Job Title 1602 - 182_184 High Holborn		Client Covent Garden Investment S.A.R.L
Drawing Title PROPOSED SECTION 02		Drawing Number & Revision HH-P-26-MF-01-02_P4
Scale (at A0) 1 : 100@A1	Date Amended 29.03.2017	Amended By GK
Checked Checker	Date Created	Drawn By Author

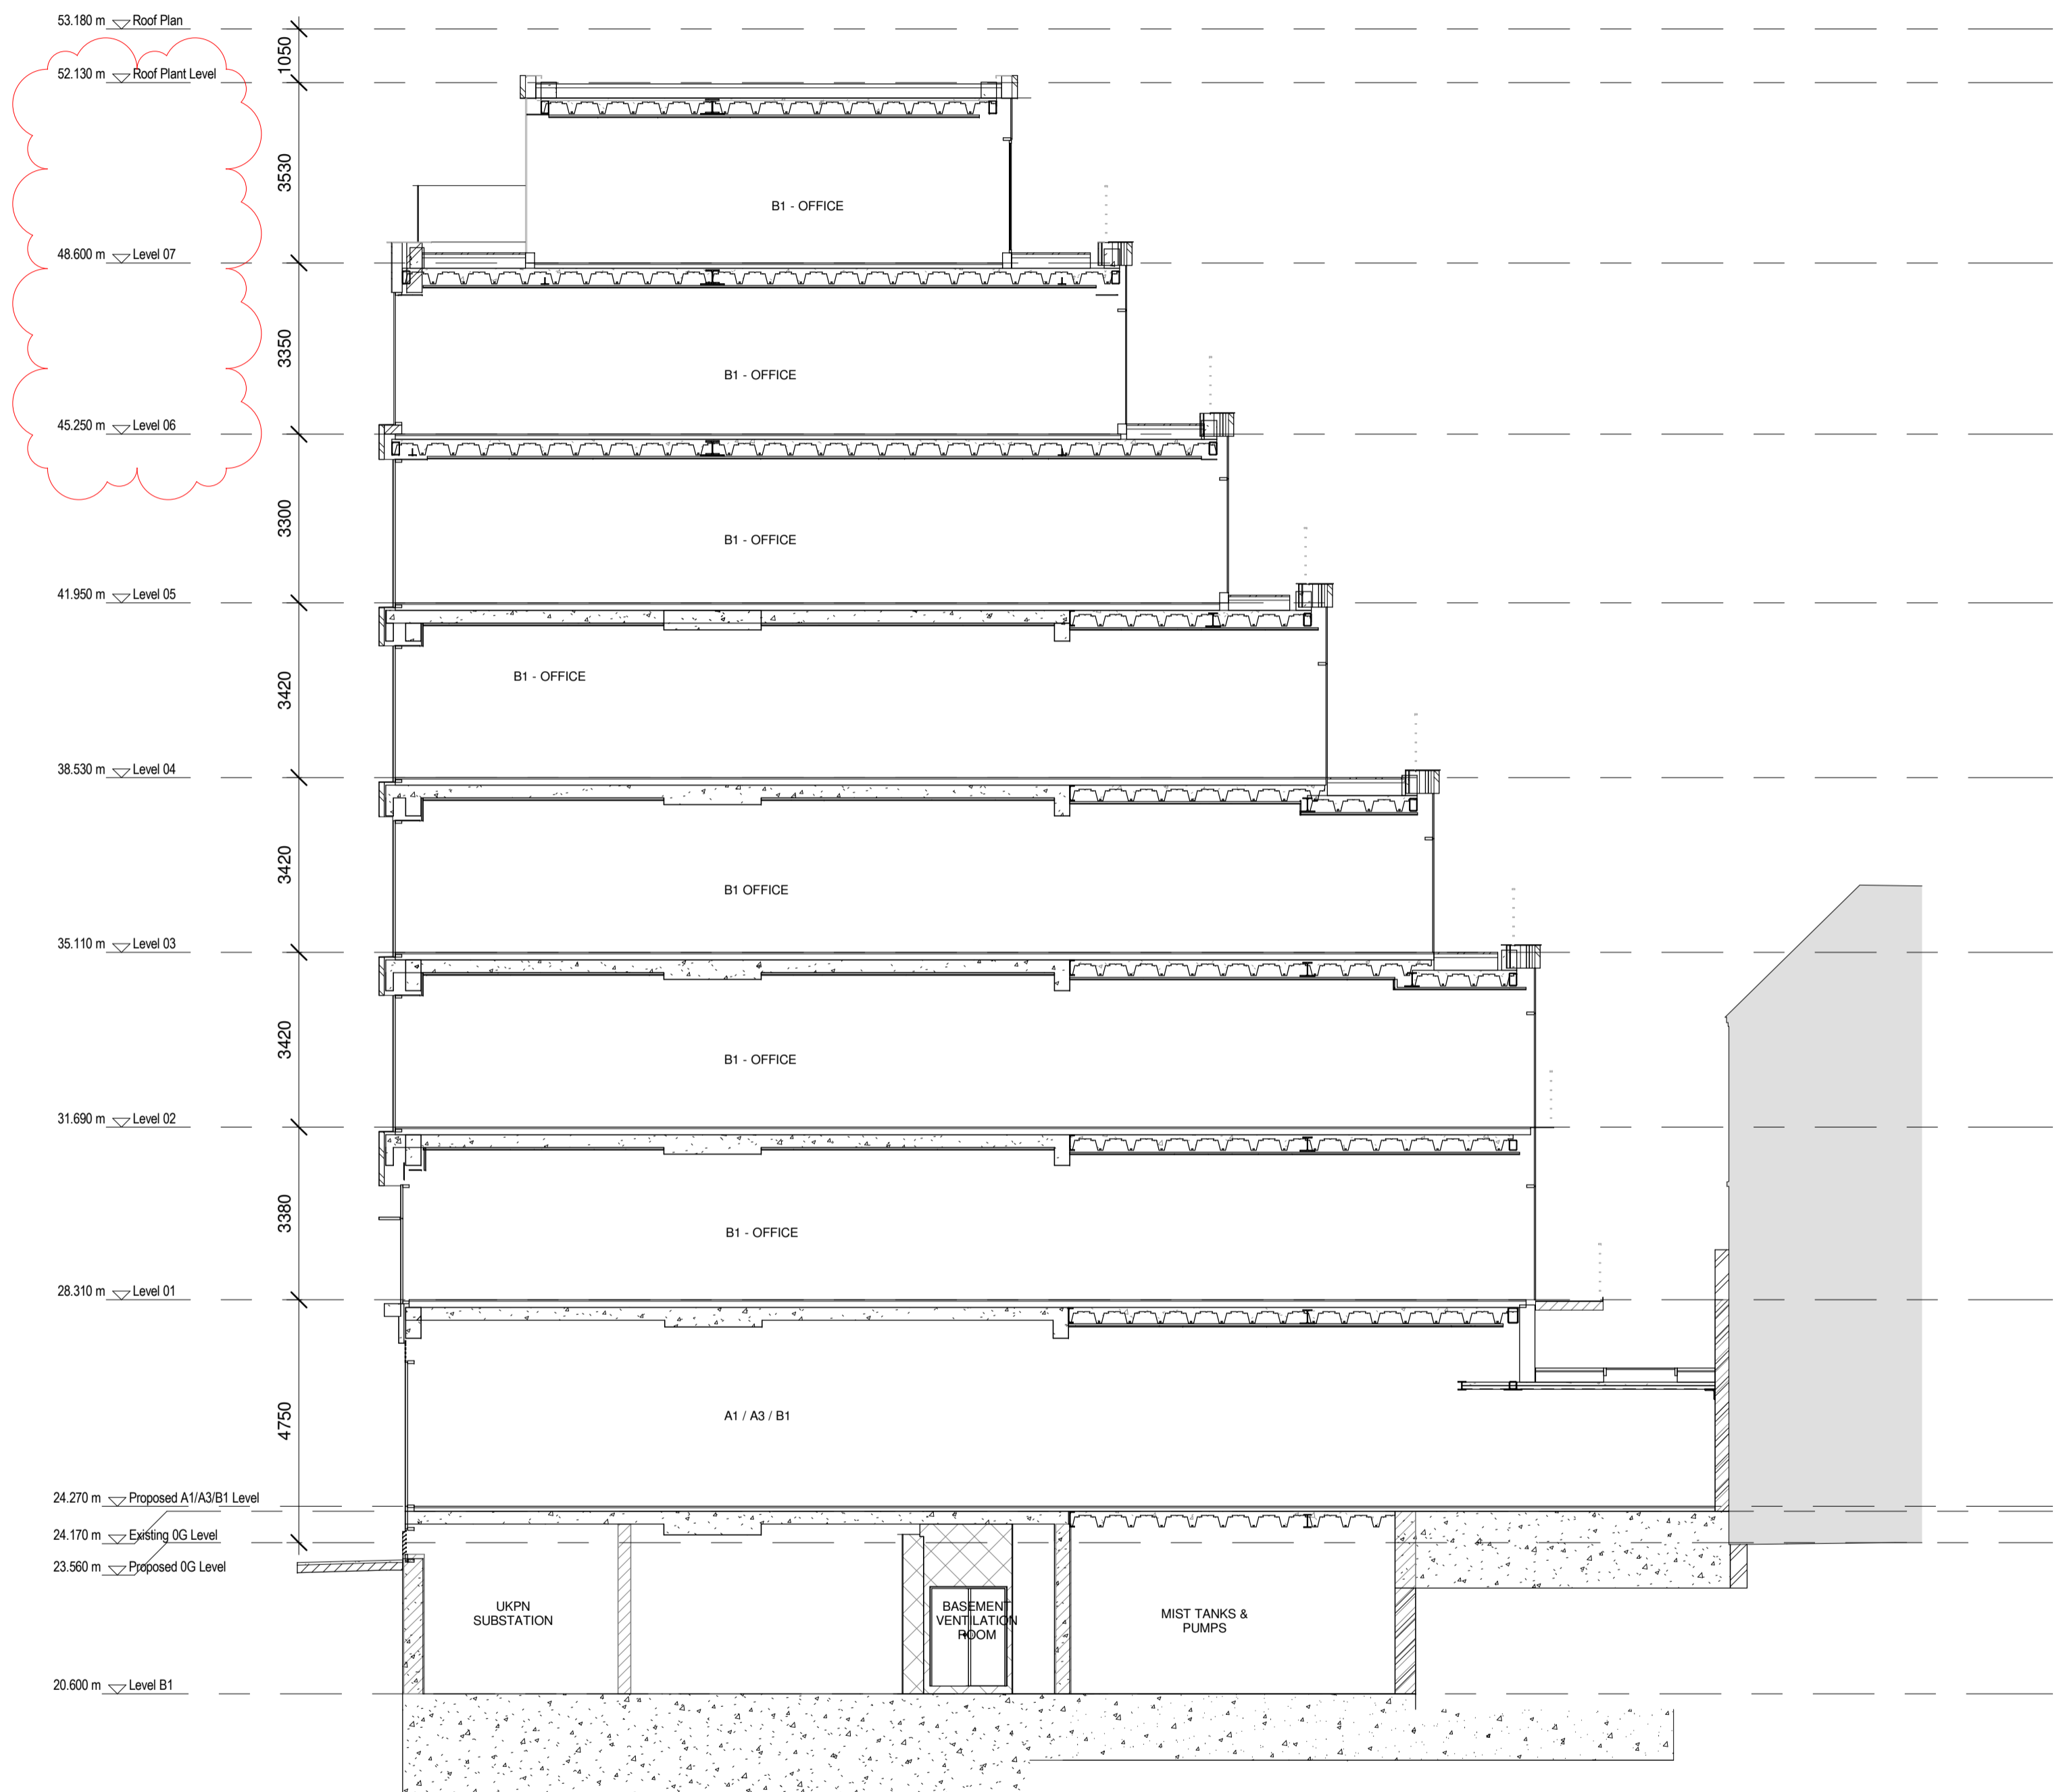
- There is an increased height on levels 6, 7 and Roof Plant in order to accommodate higher clear ceiling heights. Level 6 (FFL) has been increased by 150mm, level 7 (FFL) by 300mm and the roof plant level by 450mm-which is the total increase of the mass in terms of height. The top roof level has remained intact.
